**MANHATTAN COMMUNITY BOARD SIX**

Mark Thompson, Board Chair, requested Mr. Fred Arcaro, Chair of the Board’s Public Safety, Environment & Transportation Committee, to produce the following comments based upon a meeting held on November 22, 2011 with representatives from the Department of Environmental Protection (DEP), Department of Design & Construction (DDC) and the Department of Transportation (DOT) to discuss the trunk water main route and the construction, for shaft site 33b of the Third Water Tunnel.

Mark Thompson, Chair of Manhattan Community Board Six (“CB6”), requested that Fred Arcaro, Chair of the CB6 Public Safety, Environment & Transportation Committee, summarize CB6’s conclusions regarding the second water main construction route. The attached report was issued earlier, but this cover memo recaps that report’s conclusions and includes additional information.

NEW YORK CITY DEPARTMENT OF ENVIRONMENTAL PROTECTION  
PROPOSED SHAFT 33B TO CITY WATER TUNNEL NO. 3  
STAGE 2-MANHATTAN LEG  
WATER MAIN CONNECTIONS

*Ex #9*

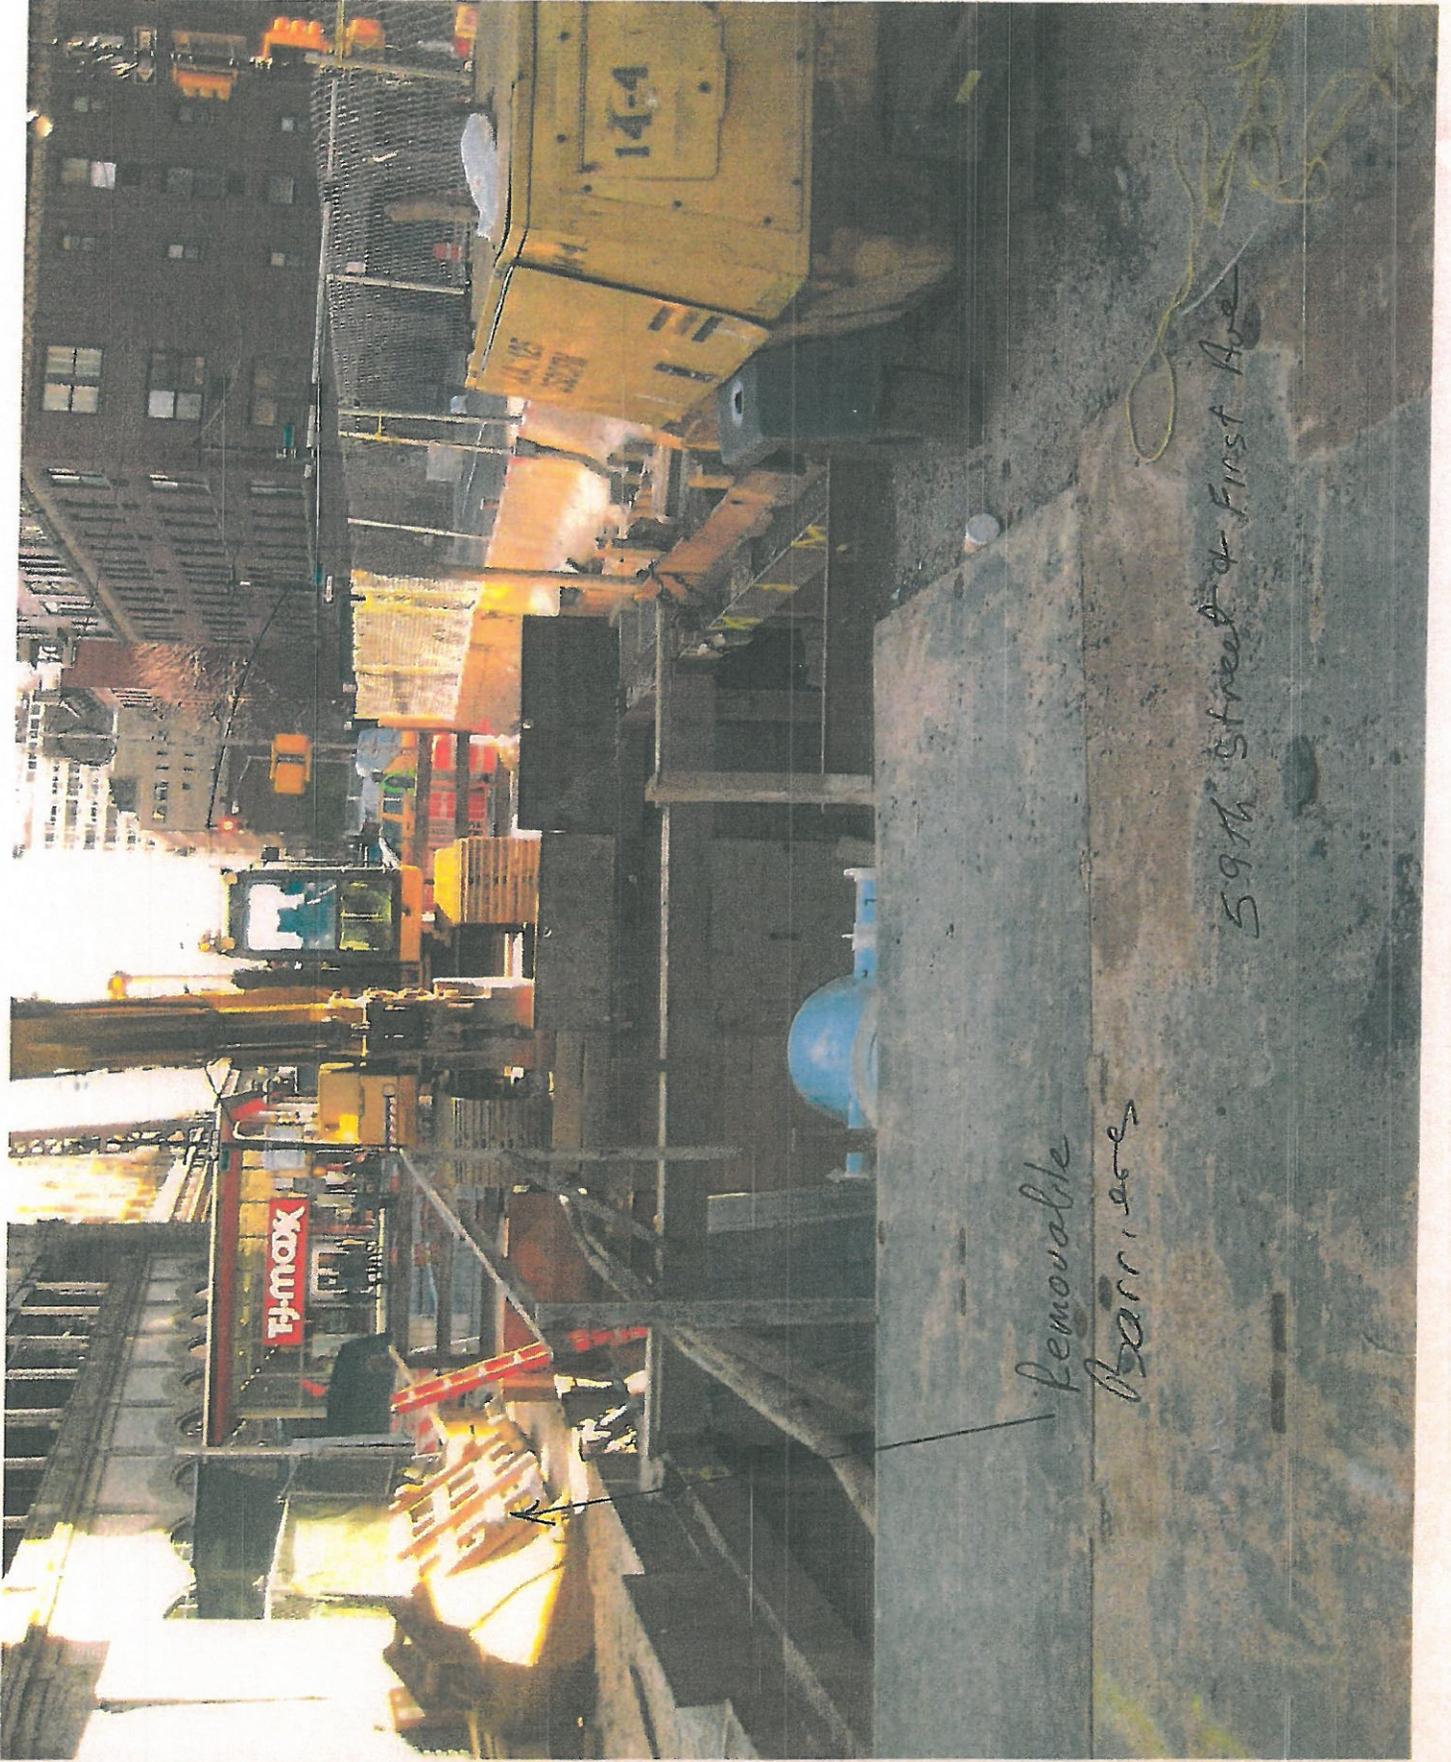
- DDC's safety concerns are inconsistent with a photograph indicating placement of jersey barriers next to one 48" water main trench at the Houston Street project (This was depicted with photographs of the Houston Street project at the presentation for CB6 "Reconstruction of Trunk Water Mains along East 59<sup>th</sup> Street" dated Feb. 2, 2010; see Exhibit #9 (marked up)). Also see Exhibits #10 and #11 showing the jersey barriers next to the water main trench for the installation of the first water main on E. 59<sup>th</sup> Street.

*Jersey  
Barriers*

Box #10

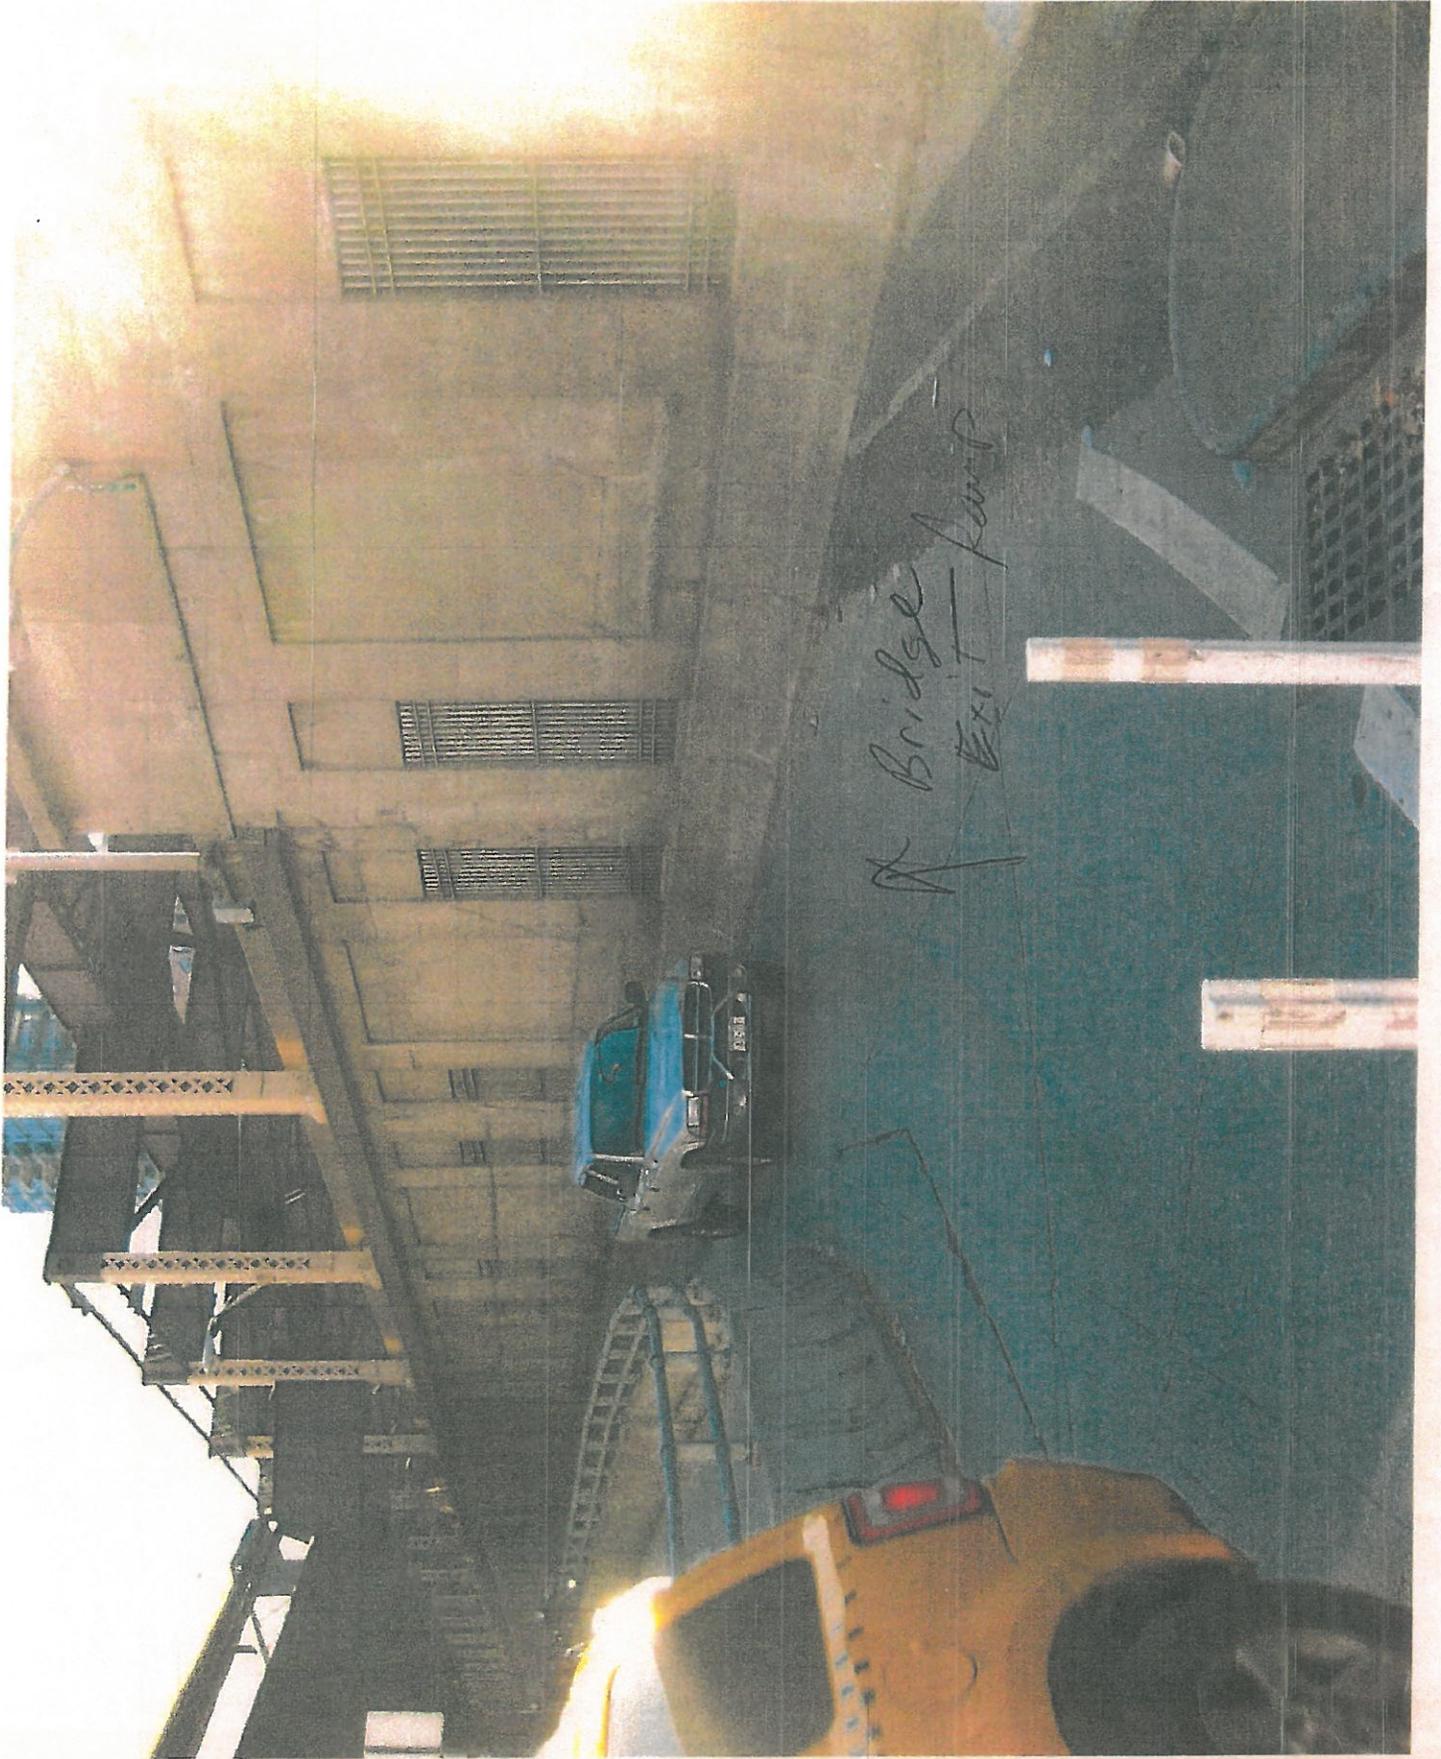
- If DDC is still concerned with safety during off-peak hours, it should consider the use of temporary plastic easily movable jersey barriers used in many road construction projects. Plastic barriers are cheaper to use than concrete. Additionally, DDC could use caution lights and other cautionary devices, which may be more appropriate for this location. See Exhibit #10 and #12 (marked up).

54 #13

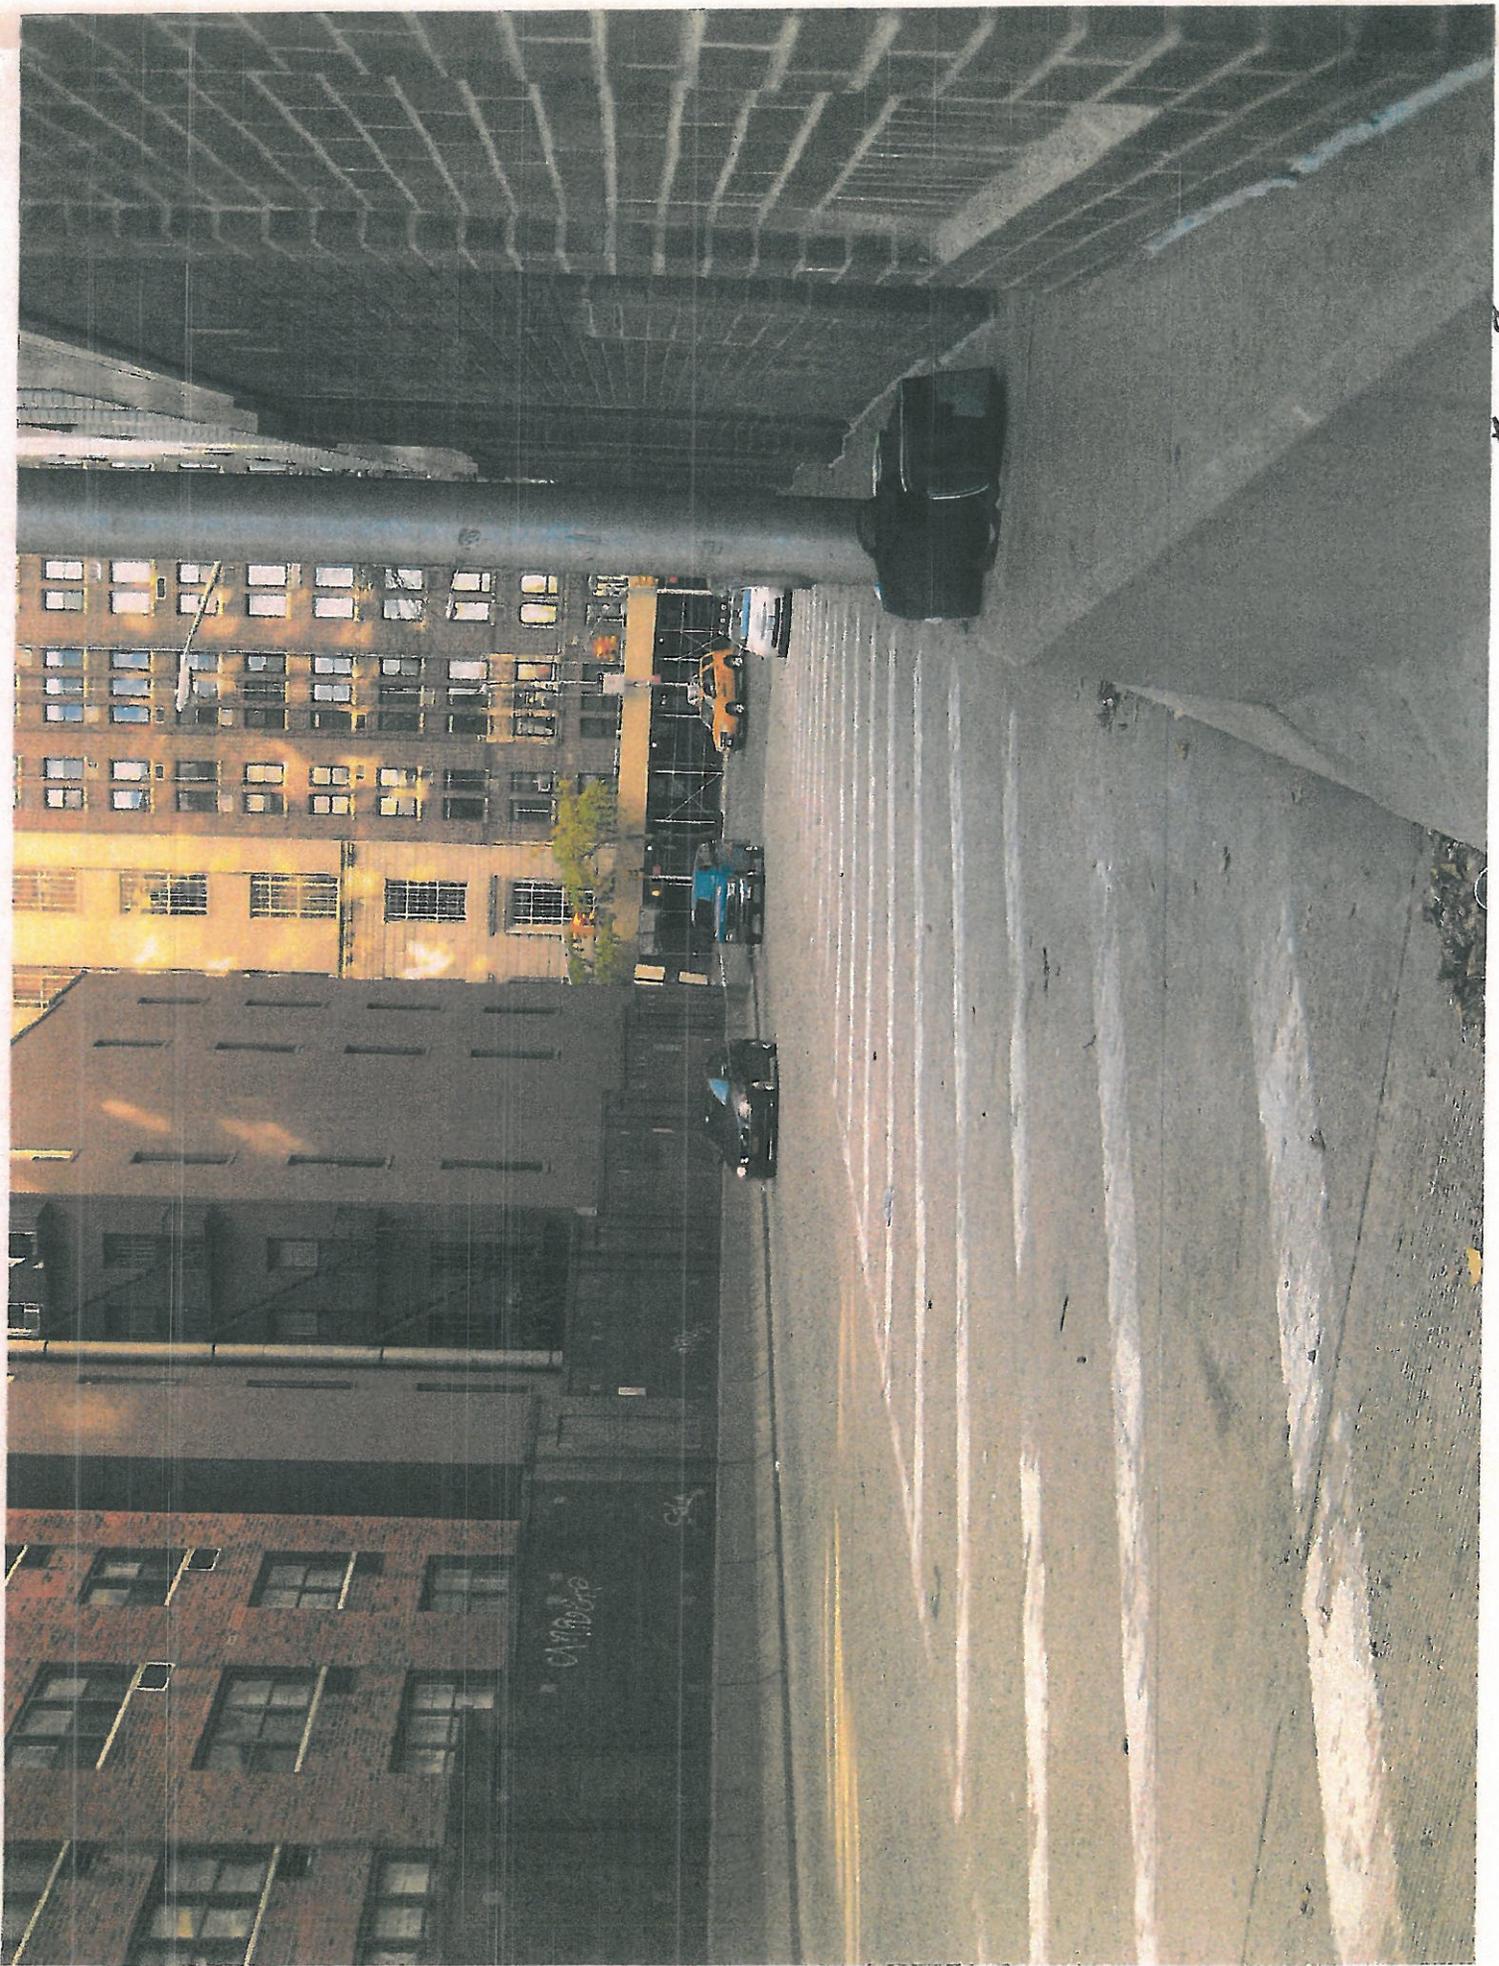
- Close the northbound midblock street between E. 60<sup>th</sup> and E. 61<sup>st</sup> Street located between First and Second Avenues. That street is used primarily for traffic exiting the Edward I Koch Queensboro (aka 59<sup>th</sup> Street) Bridge. See Exhibit #13.

- Since the midblock street would be closed to traffic from the one lane bridge exit (see Exhibit #14 marked up) traffic could be directed to use E. 60<sup>th</sup> Street to go west once the sign has been changed. The traffic volume on E. 61<sup>st</sup> between midblock and Second Ave. would then be 579 during peak, and would be maintained past the midblock street. This reduced traffic volume would be less than on E. 58<sup>th</sup> Street which is 726 during AM peak periods. See Exhibit #2, #4 and #13 marked up.

Street to  
close
